ADMINISTRATIVE AMENDMENT

MARKANA APARTMENTS - II
SAN PEDRO AND ALAMEDA
Albuquerque, New Mexico

Amendment 04/22/2021:
Increased building height;
consistent with the RM-H Zone
As Built - Parking Count Revised
August 19/2020

BUILDING TYPE 2 AND 3
ELEVATIONS

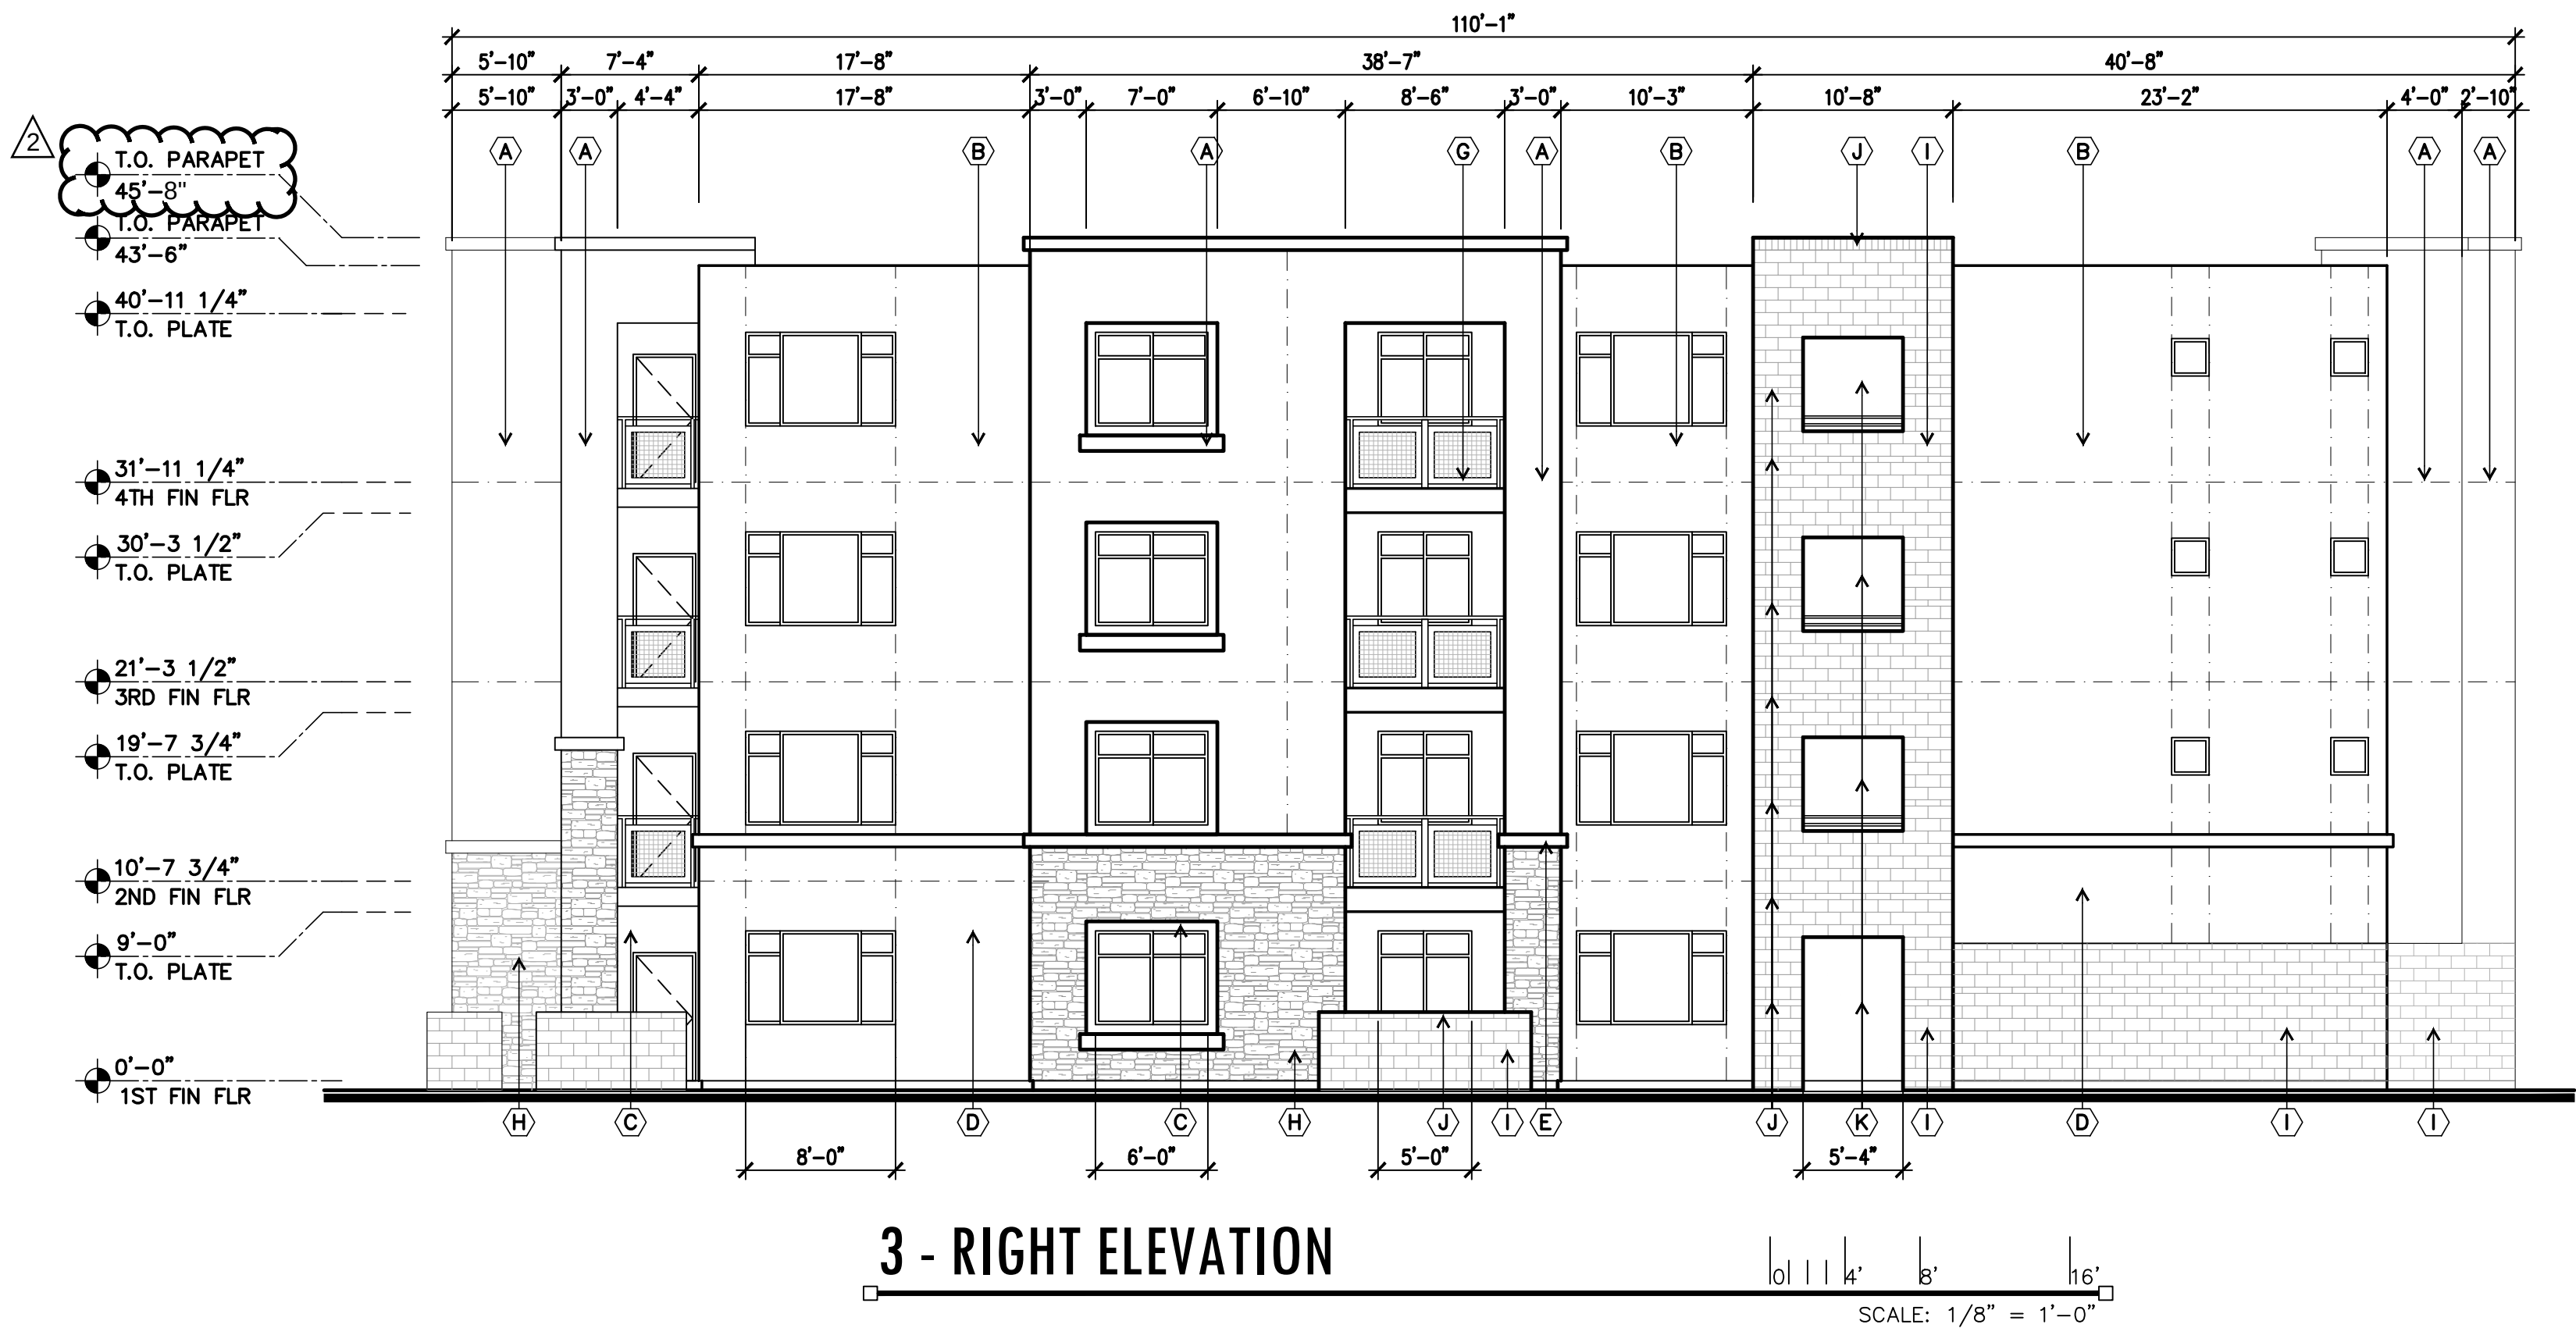
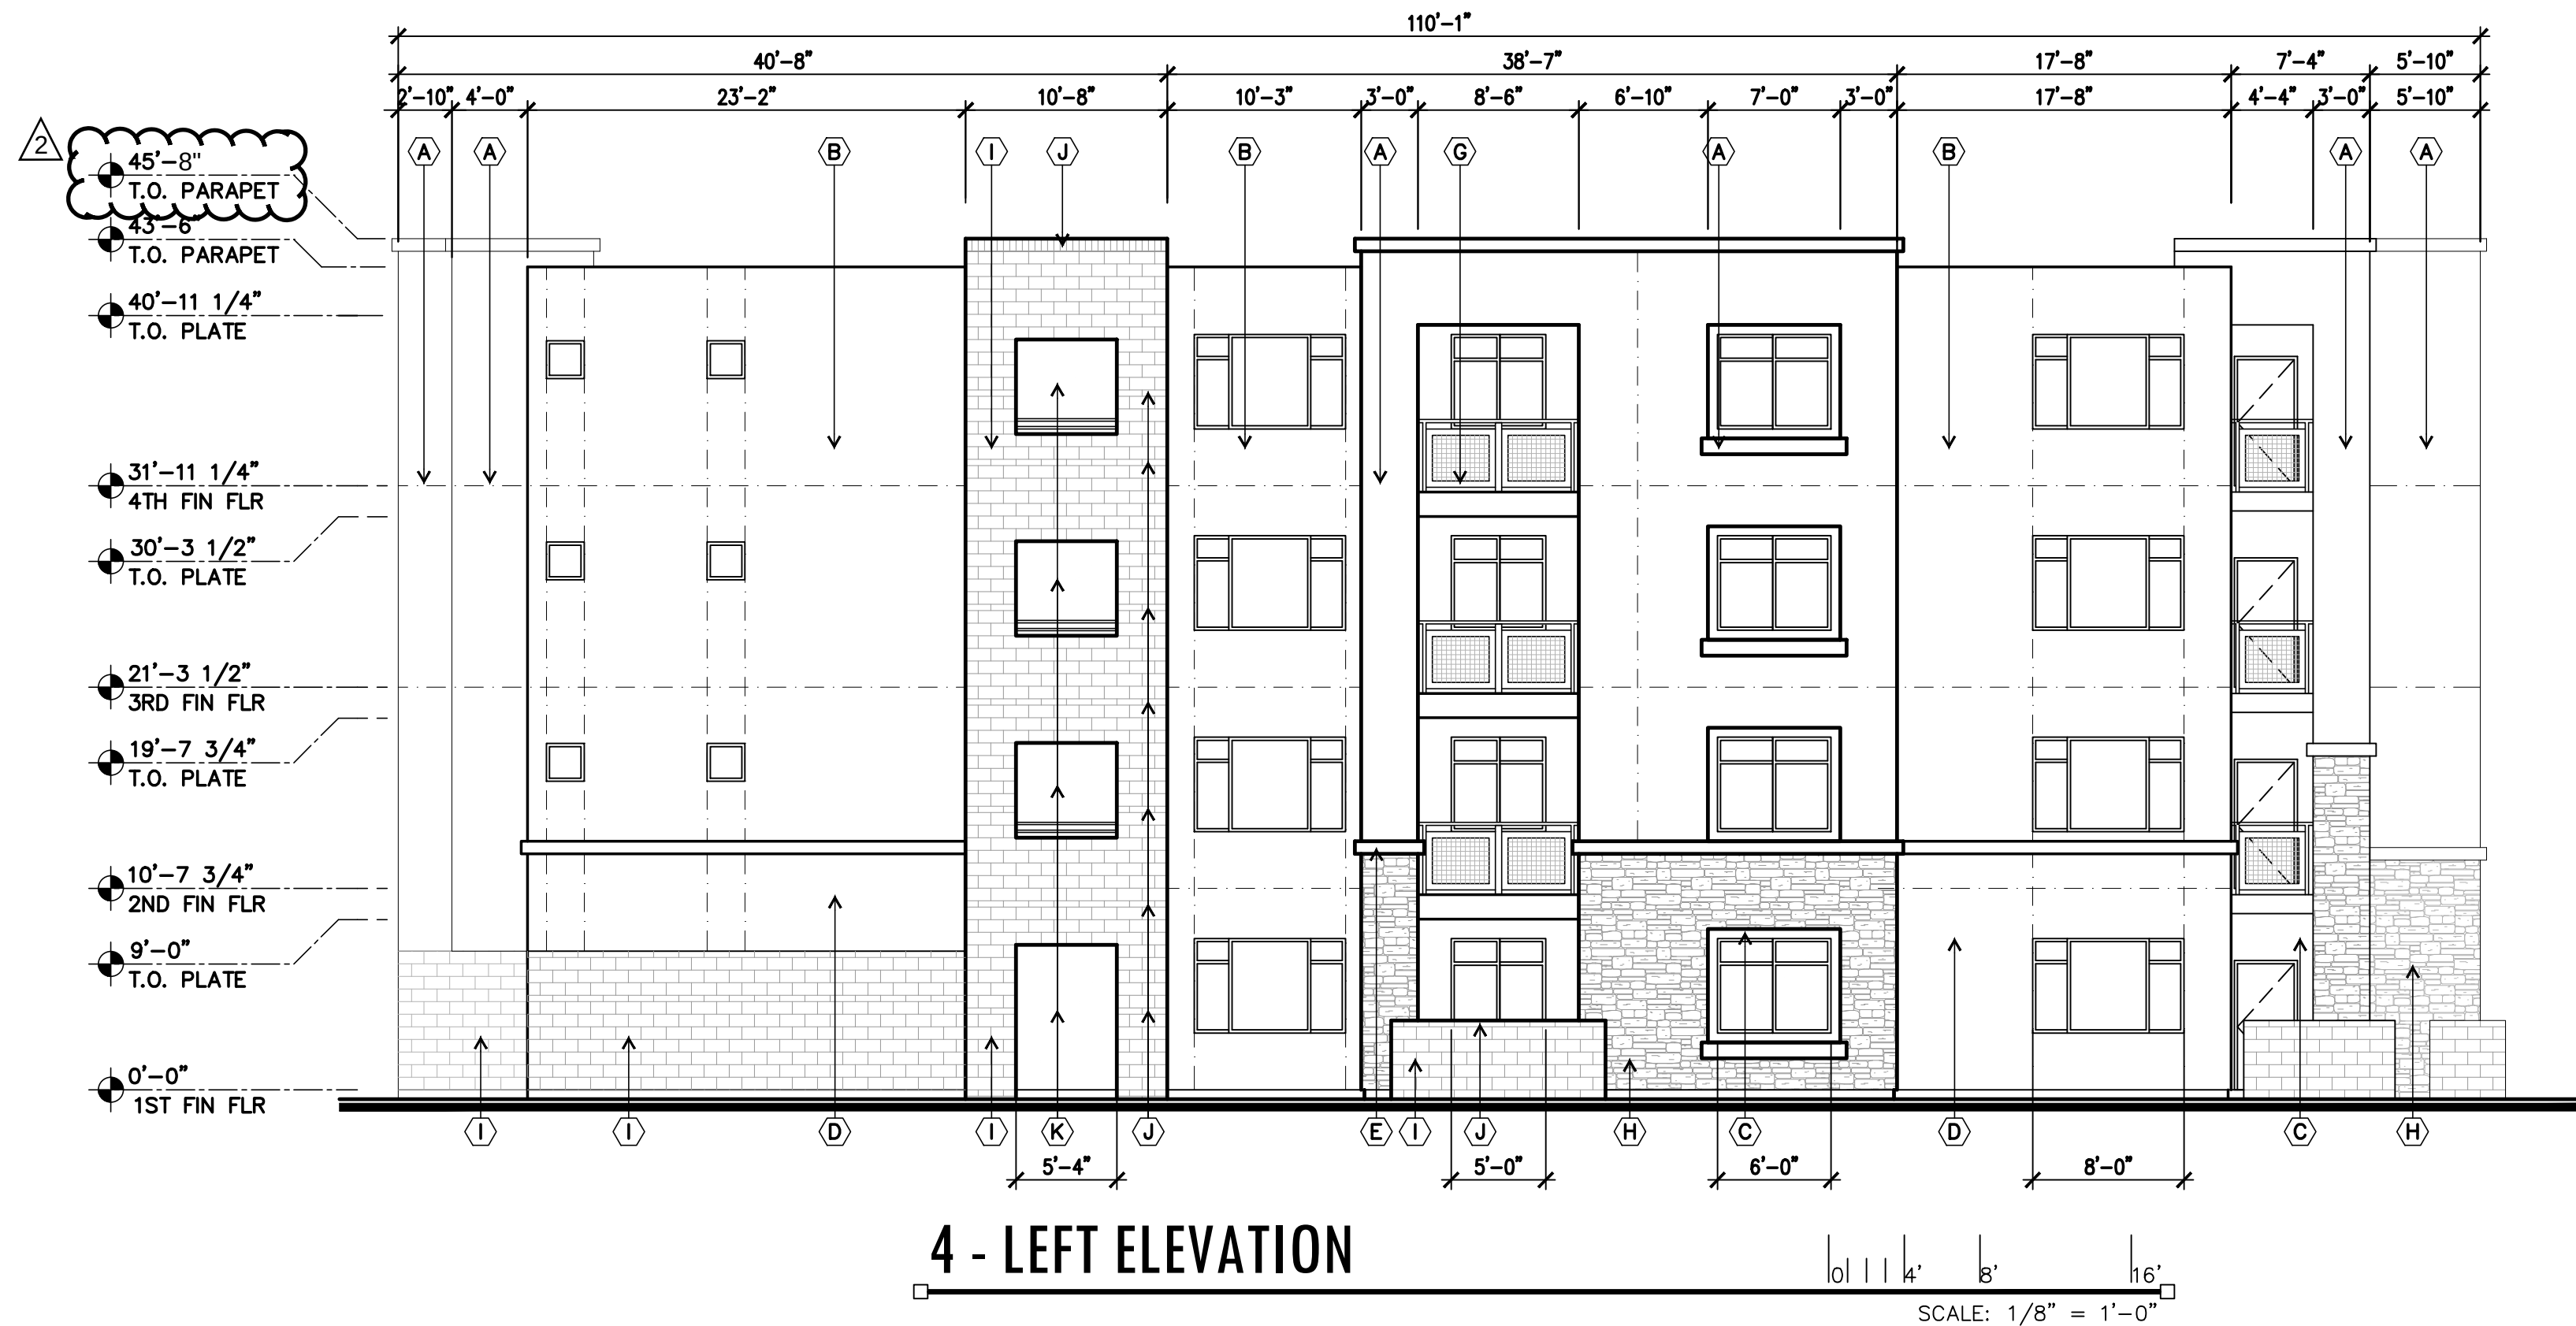
Amendment 04/22/2021:
Increased building height;
consistent with the RM-H Zone
